**Re: Elysian Subdivision Waterlines ([PR#150-2024](#))  
McMinnville Water & Light ([PWS ID#00497](#))  
Conditional Approval**

The plans are approved subject to meeting the following conditions:

Drawing C5.0 (Construction Notes)  
addressed water-sewer separations  
as shown in note 65 below:

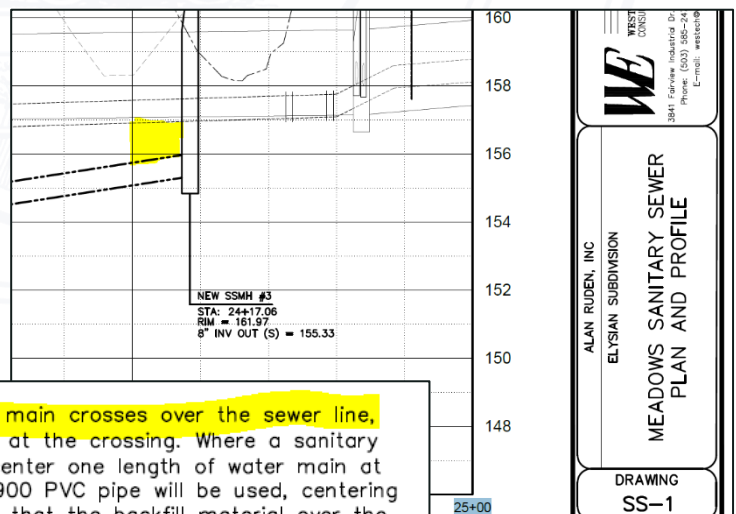
65. If less than 18" of separation occurs when the water main crosses over the sewer line, then contractor must center one length of the water line at the crossing. Where a sanitary sewer main crosses above a water line, contractor shall center one length of water main at the crossing. If it is a sewer lateral, one full length of C900 PVC pipe will be used, centering it over the water main. Contractor must take precautions that the backfill material over the water line in the vicinity of the crossing is thoroughly tamped in order to prevent settlement.

4. Water-sewer line crossings meet OAR 333-061-0050(9) available online at:  
<https://www.oregon.gov/oha/PH/HEALTHYENVIRONMENTS/DRINKINGWATER/PLANREVIEW/Documents/OAR-333-061-0050.pdf>

Drawing W-1 (Overall Water Plan) indicated the following notes while Drawing W-2 (Water Details) showed the following trench detail:

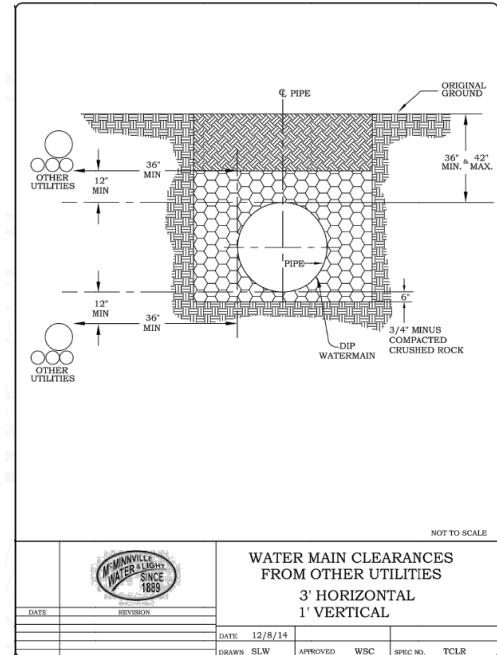
- NOTE 6 – SEE SHEET G-12 FOR CITY OF McMINNVILLE TRENCH EXCAVATION & BACKFILL DETAIL.
- NOTE 7 – MAINTAIN A MINIMUM 3' HORIZONTAL AND 1' VERTICAL SEPARATION BETWEEN NEW/EXISTING WATER MAINS AND OTHER UTILITIES, OTHER THAN SEWER (UNLESS OTHERWISE SHOWN ON PLAN).

- NOTE 8 – CONTRACTOR TO PULL PLUMBING PERMIT FROM CITY FOR ALL PRIVATE SERVICES INSTALLED.
- NOTE 9 – REFER TO SEWER PLANS FOR APPROX. DEEPER DEPTH OF WATER LINES AT SAN. SEWER CROSSINGS.

- NOTE 10 – REFER TO McMINNVILLE WATER & LIGHT'S "APPROVED MATERIAL LIST" at MC-POWER.COM. ALL MATERIALS MUST BE AWWA APPROVED, NSF61 CERTIFIED/ INCLUDING ANNEX G/NSF372 CERTIFICATION FOR LOW LEAD IF APPLICABLE.

- NOTE 11 – IF LESS THAN 18" OF SEPARATION OCCURS WHEN THE WATER MAIN CROSSES THE WATER LINE AT THE CROSSING. CONTRACTOR MUST CENTER ONE LENGTH OF THE WATER LINE AT THE CROSSING.

- NOTE 12 – WHERE SANITARY SEWER LINES CROSSES ABOVE A WATER LINE WITH LESS THAN 18-INCHES OF VERTICLE SEPARATION, CONTRACTOR SHALL CENTER ONE LENGTH OF C900 PVC PIPE OVER THE ONE PIECE OF CENTERED WATER MAIN. IF IT IS A SEWER LATERAL, ONE FULL LENGTH OF C900 PVC PIPE CAN BE USED AS A SLEEVE, CENTERED OVER THE WATER MAIN. CONTRACTOR MUST TAKE PRECAUTIONS THAT THE BACKFILL MATERIAL OVER THE WATER LINE IN THE VICINITY OF THE CROSSING IS THOROUGHLY TAMPED IN ORDER TO PREVENT SETTLEMENT. CONTRACTOR MUST CHECK WITH PROPER JURISDICTION AS TO WHETHER A SEWER MAIN CAN CHANGE MATERIAL IN A RUN OR NOT.

- NOTE 13 – AN AASHTO T99, METHOD D, COMPACTION TEST IS REQUIRED OF PUBLIC WATER FACILITIES INSTALLED IN PUBLIC STREETS. RESULTS NEED TO BE SUBMITTED TO MW&L.
